RIDGWAY PLANNING COMMISSION

REGULAR MEETING AGENDA

Tuesday, November 30, 2021

To: Town of Ridgway Planning Commission
Cc: Preston Neill, *Ridgway Town Manager*
From: TJ Dlubac, AICP, *Community Planning Strategies, Contracted Town Planner*
Date: October 21, 2021
Subject: McIsaac Subdivision Planned Unit Development Preliminary Plan and Plat for October 26th PC Meeting

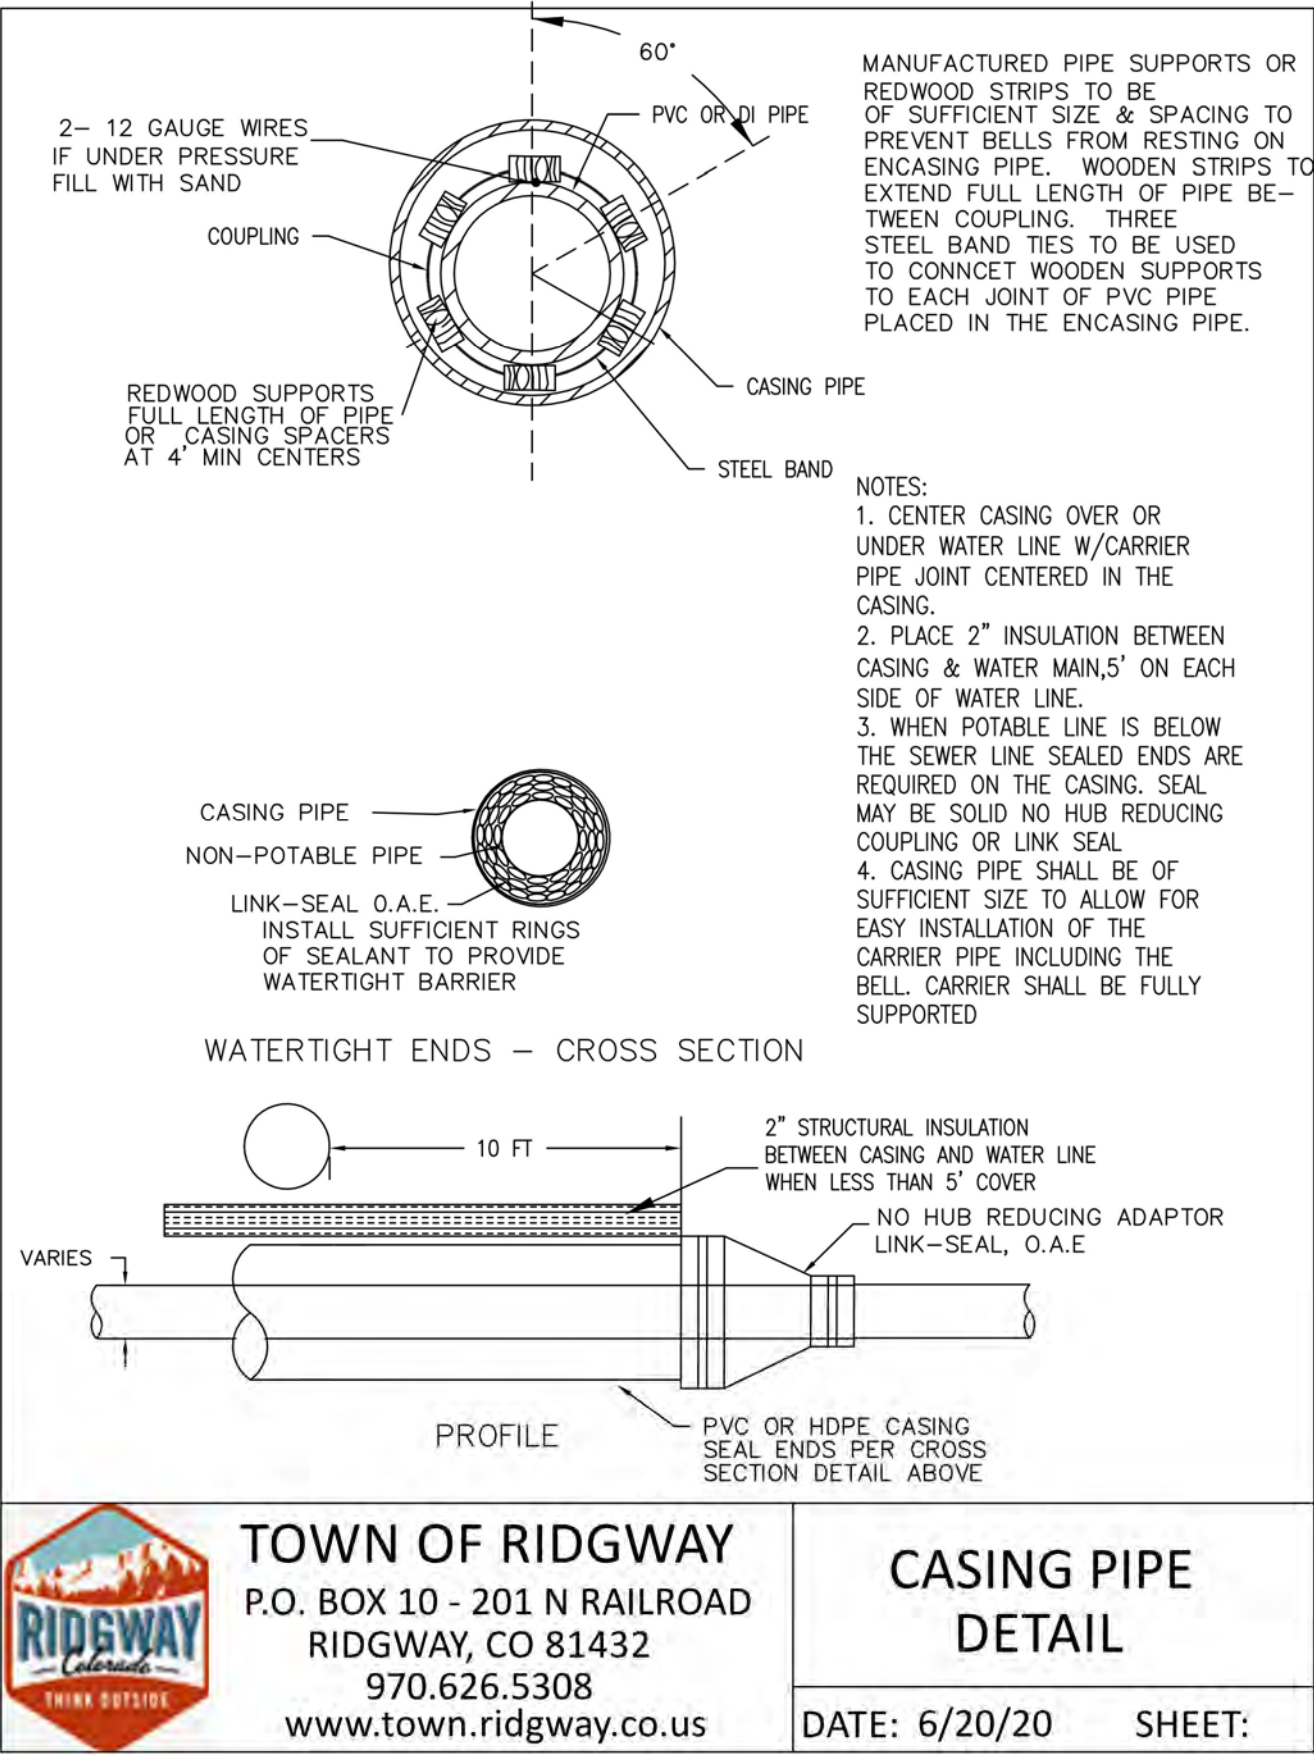
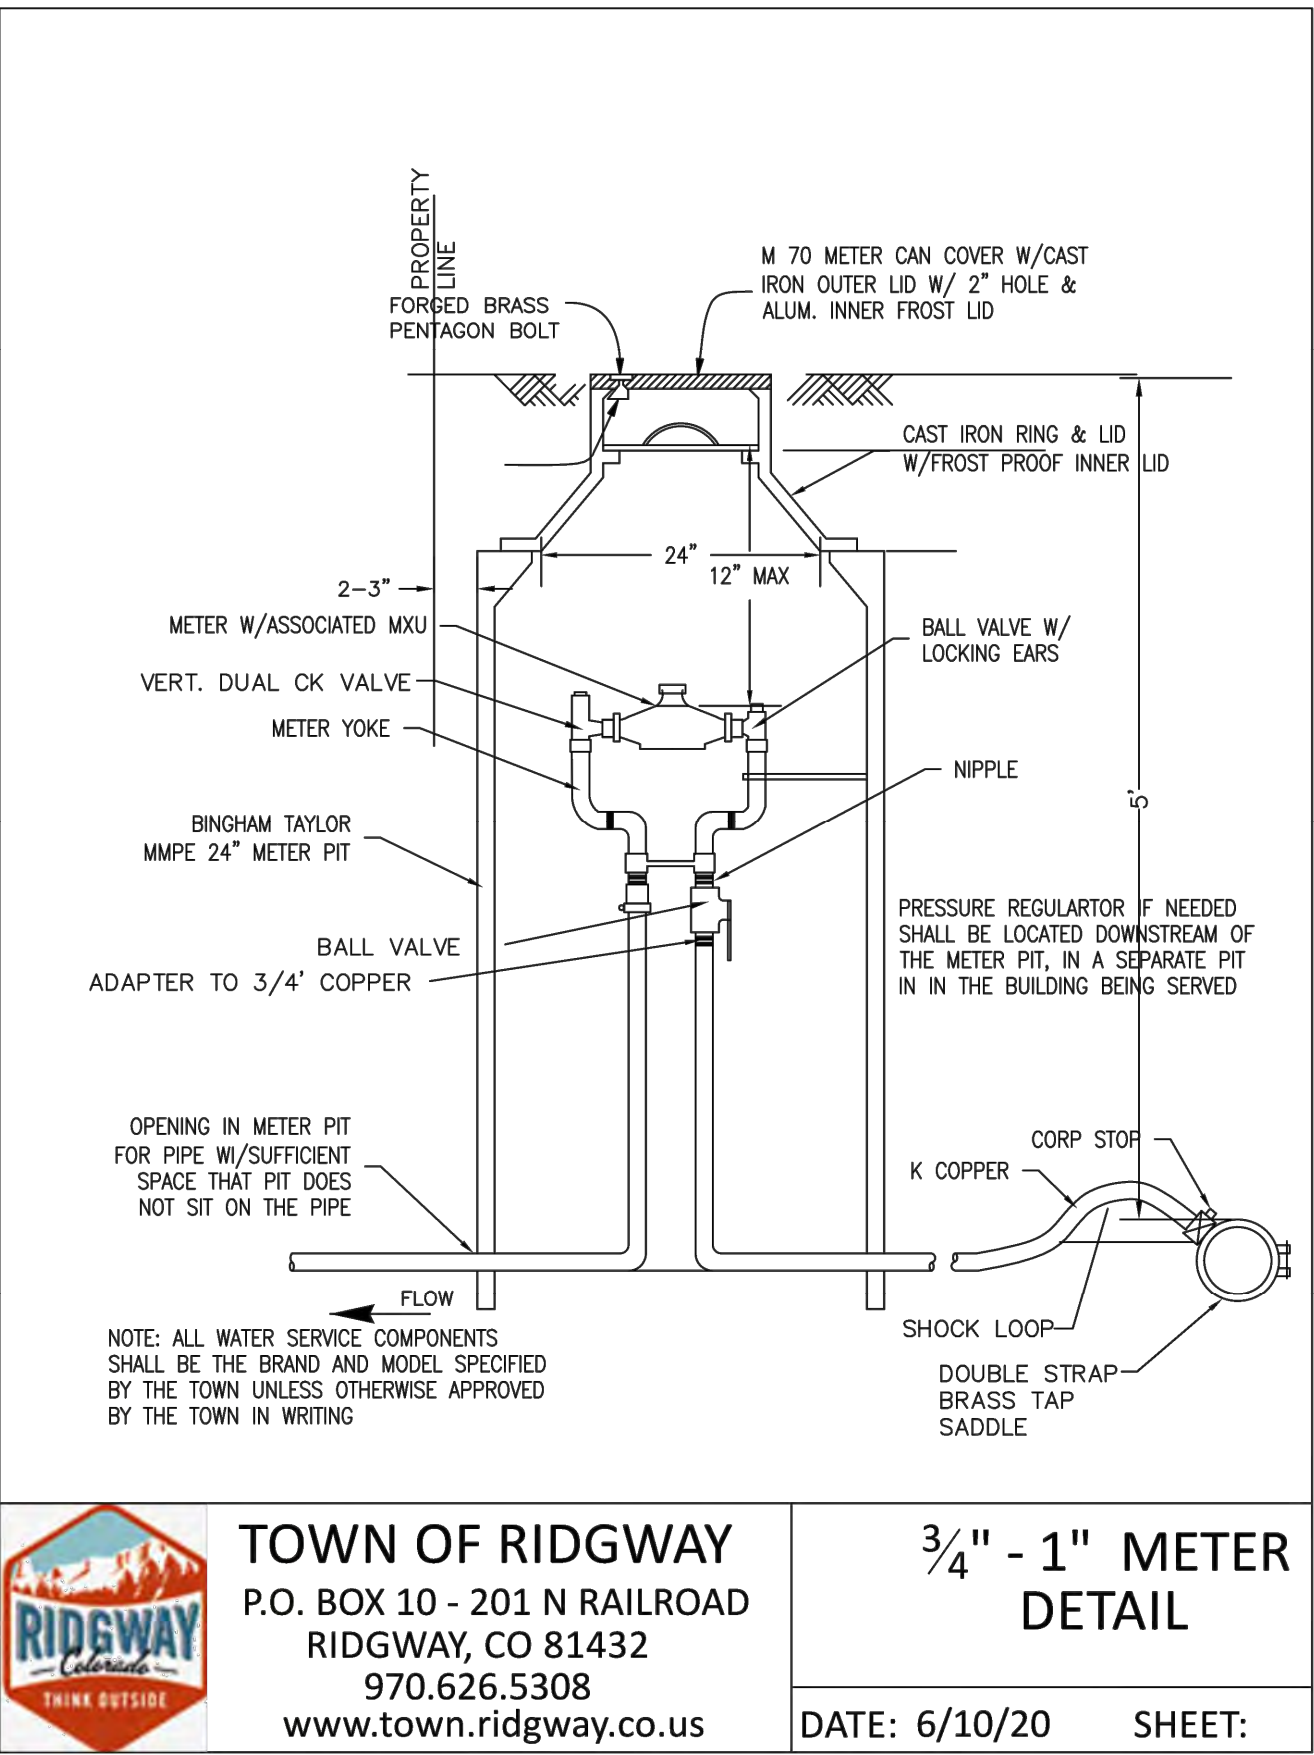
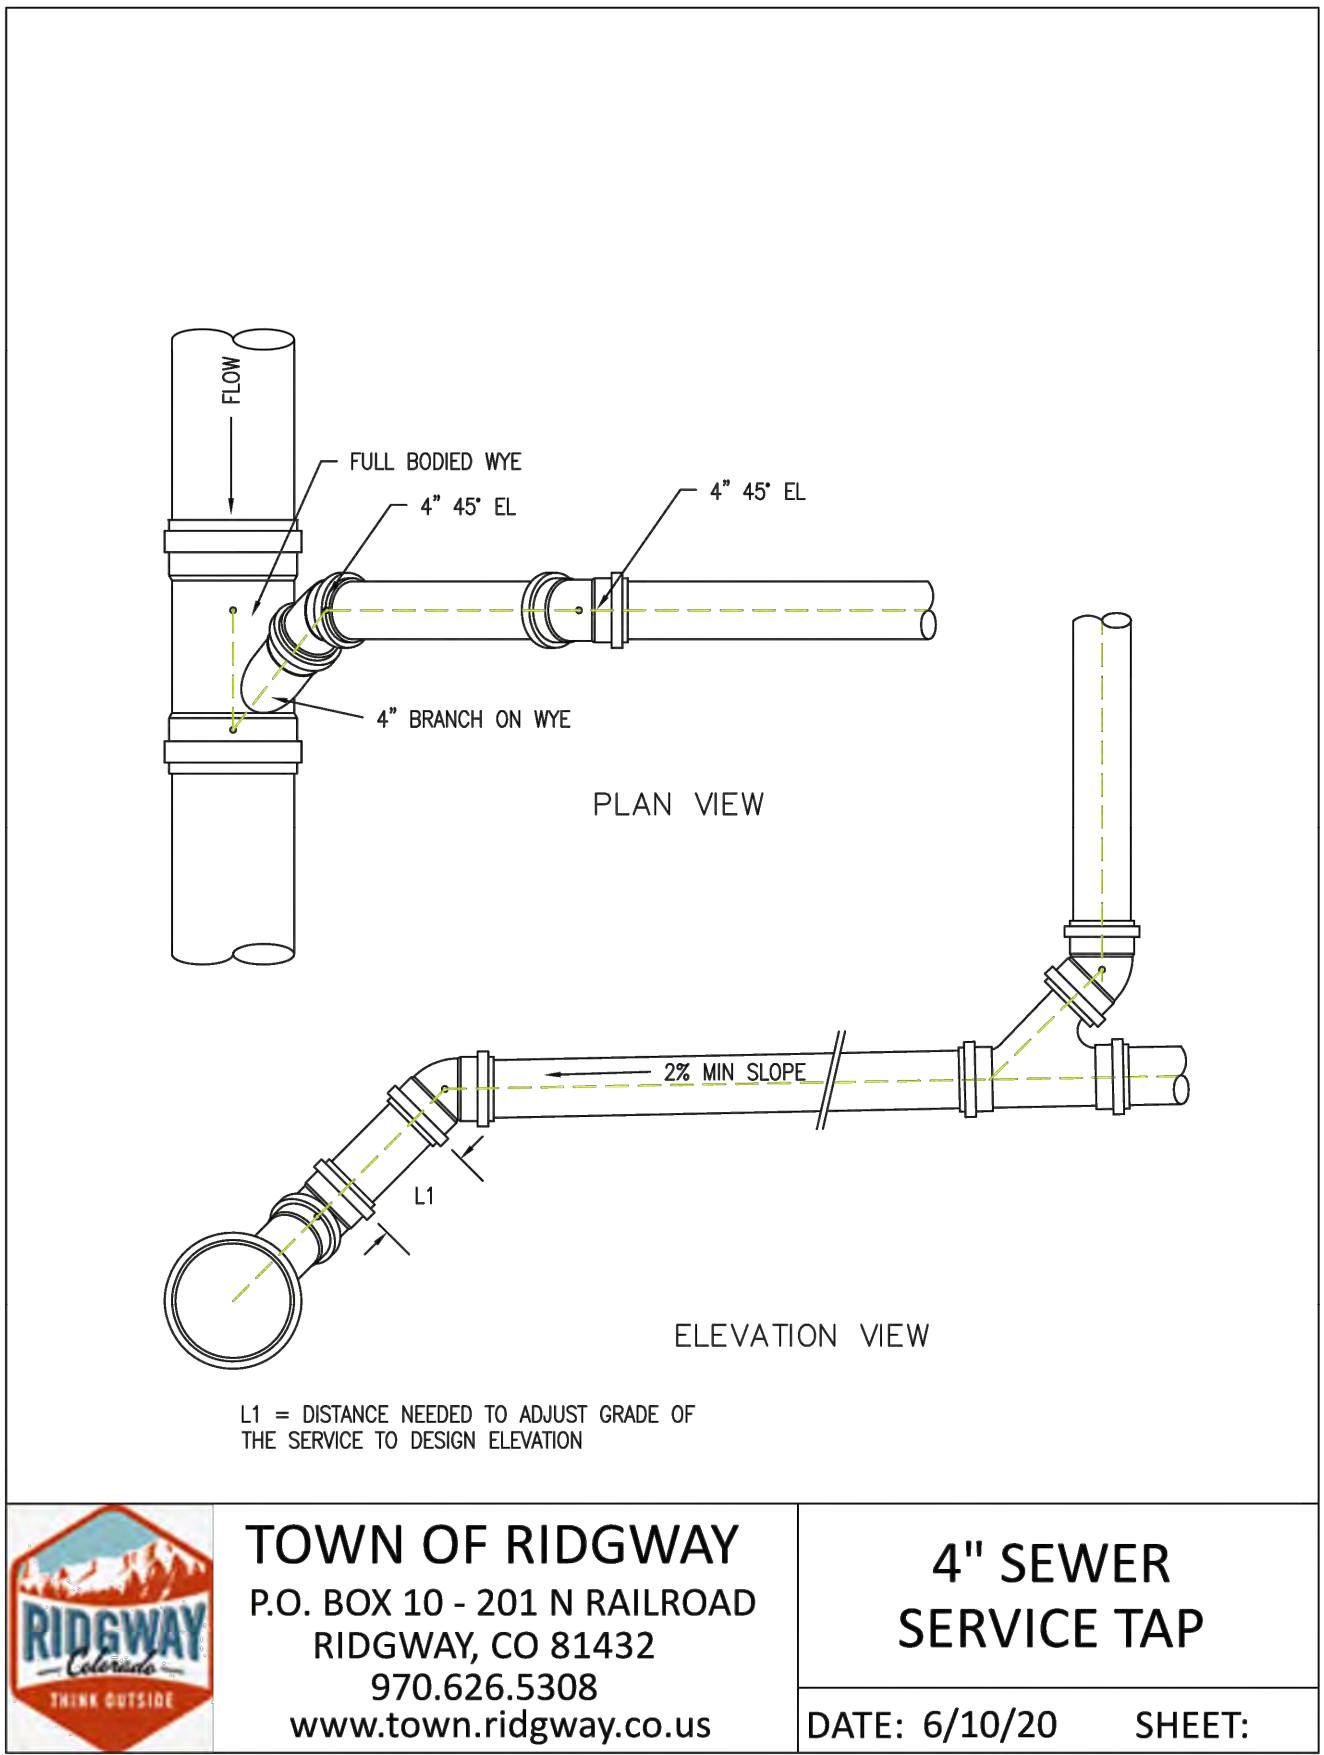
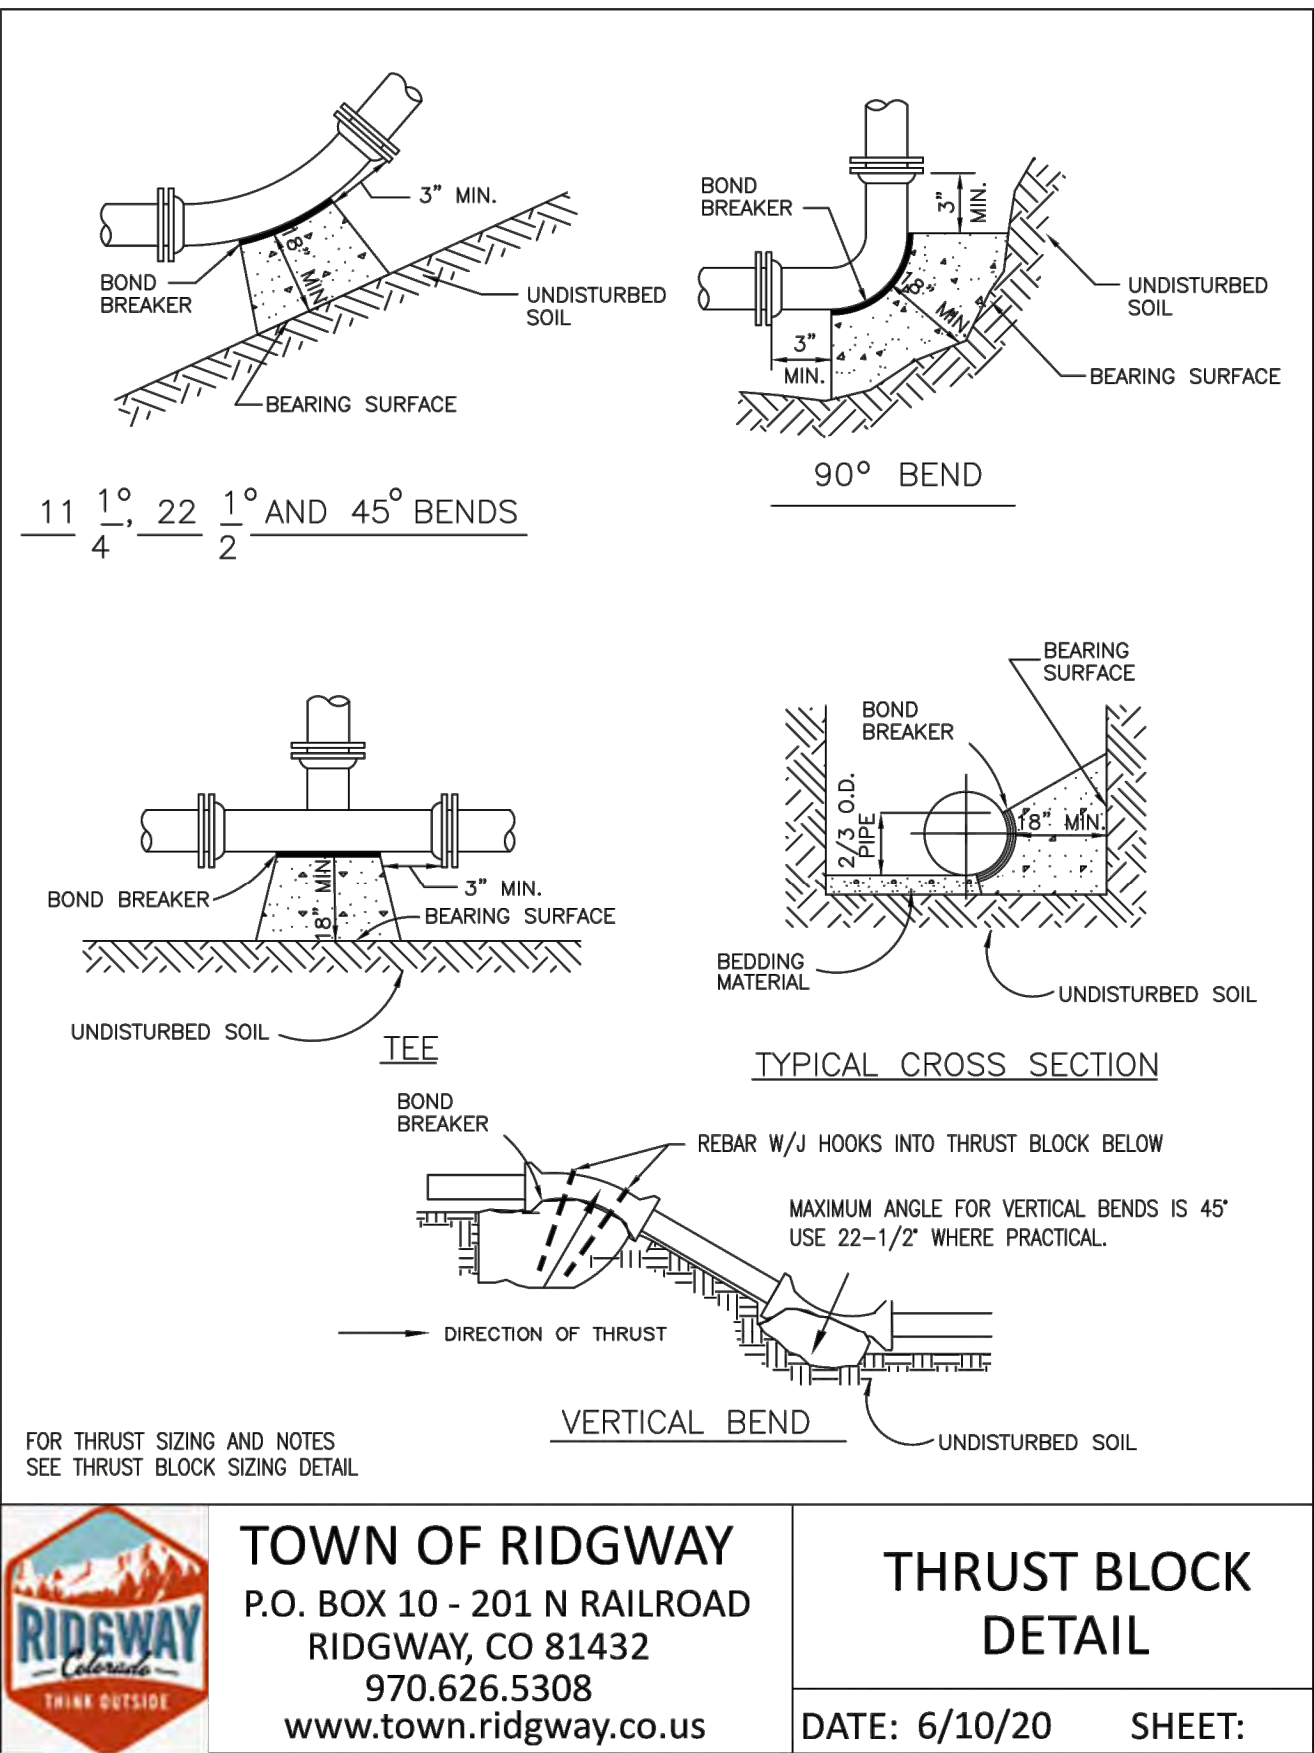
C6.1	Details	Curb Ramp Type3	Where is this proposed for use?	The plans should call out which curb ramp type from the M standard is needed in each locaton. Spot elevations should be provided to demonstrate maximum slopes won't be exceeded.	Please see sheet C2.0 for curb ramp type.	
C6.1	Details	Sidewalk Detail	The cross slope of the sidewalk can not exceed 2%, rather than that being the minimum percent. We recommend that the sidewalk be designed at 1.8% cross slope to leave room for a little construction error	Not addressed	Language updated from minimum to maximum slope of 2%. Detail has been moved to sheet C6.0.	
C6.1	Details	Curb and Gutter	Did the sketch plan approval require the wider sidewalk referenced in the notes on this detail? If so, then the sidewalk should be 8' wide. If the PC did not address this, I believe the notes are not relevant and the walk can be 5' wide.	Walks shall be at least 5' wide.	All sidewalks are 5' wide.Called out and dimensioned on sheet C2.0.

C6.1	Details	Encasement	The town prohibits concrete encasements in most cases. Please detail this detail and reference the Town typical drawing.	Added town typical		
C6.1	Details	Cross pan	Where is this proposed for use?	Not addressed	Potential use would be alley crossing at Cora St. May not be within developer scope.	
C6.1	Details	Standard Pipe Trench	Please use the Town typical detail instead of this detail. If there are items in the Town detail you would like include, please let us know what they are and we will evaluate	Added town typical

C6.1	Details	Curb Ramp Type3	Where is this proposed for use?	The plans should call out which curb ramp type from the M standard is needed in each locaton. Spot elevations should be provided to demonstrate maximum slopes won't be exceeded.	Please see sheet C2.0 for curb ramp type.	Have added details and reference to CDOT stds. If there is 6' or more from sidewalk to the back of curb, there should be no need to depress the sidewalk. Where there is a need to depress, that should be labelled with stationing, coordinates and spot elevations. Those are also needed around the ADA ramps. The typical 1/C6.0 says driveway widths are on the plans. I did not find those. I also did not find valley pan widths on the plans

C6.1	Details	Surface Drain				The bedding material is called out as Class I, II, or III ASTM 2321. I believe Class II is a single graded material. If that is used what keeps out the fines from above. Why not use a low permeability pipe bedding material per town standards. What is the material intended for the vertical tube and cap?						
C6.2		Water Meter Pit	Please use the Town typical detail instead of this detail. If there are items in the Town detail you would like include, please let us know what they are and we will evaluate	Added town typical. Given that they will have concrete walk and a landscape space, the town would prefer a curb stop and box instead of the ball valve in the meter can. That will be an update on the town standards later this year.		Please add a note to use the curb stop per the existing service detail rather than the ball valve						
C6.2	Details	Water Service Connection	The detail you have for the curb box is not covered in the Town standard. If the curb box is slip and the bonnet over the curb stop is placed so the pipe is in the middle of the opening, the block under the stop is a good idea. Just add notes to require a slip box and centering the pipe	Their detail is gone. We like their idea of the block under the stop. We will add that to the typical when we update later in the year.		Please add to note to put the block under the curb stop
